Record of Technical Discussions  
on the Basic Design Study  
on the Project for Improvement of Security Facilities and Equipment  
in Sihanoukville Port and Phnom Penh Port  
in the Kingdom of Cambodia

## Record of Technical Discussion

**Minutes of Discussions  
on the Basic Design Study  
on the Project for Improvement of Security Facilities and Equipment  
in Main International Ports in the Kingdom of Cambodia  
(Explanation on the Draft Report)**

Annex 4 CABLE INSTALLATION ROUTE

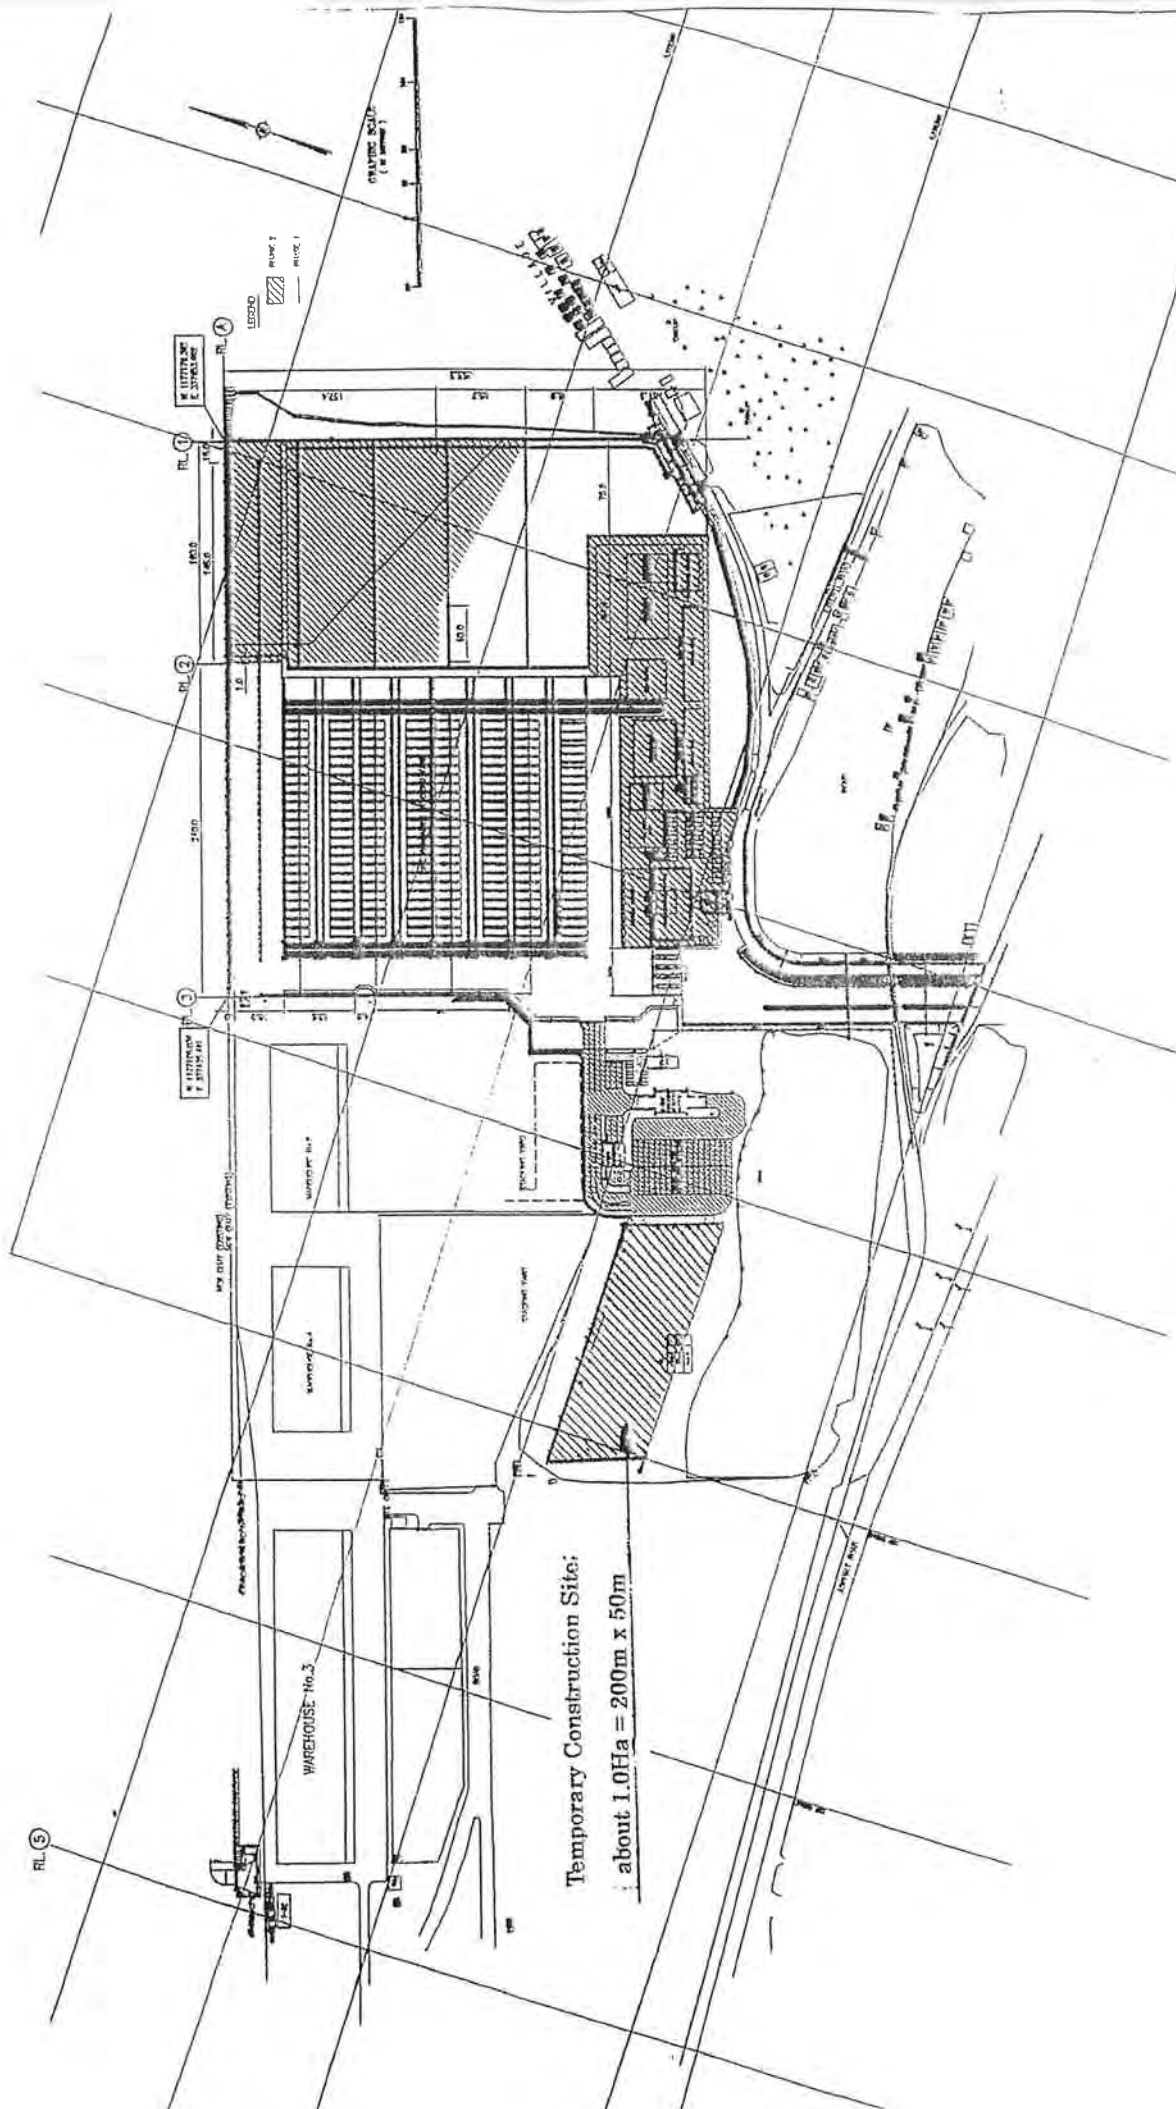
2. To provide utility with enough capability (power, water, sewage, telecommunication and others) at the location specified in the design. Required power intensity: approx. 75 kVA, 380/220 V	CED	Aug. 2007
CCTV	1. To secure site for underground cabling route. (see Annex-4 for Cable Installation Route)	PAS	Aug. 2007

2. To secure site for cabling route between tower and operation & monitoring room in Administration Office. (see Annex-4 for Cable Installation Route)	PAS	Aug. 2007
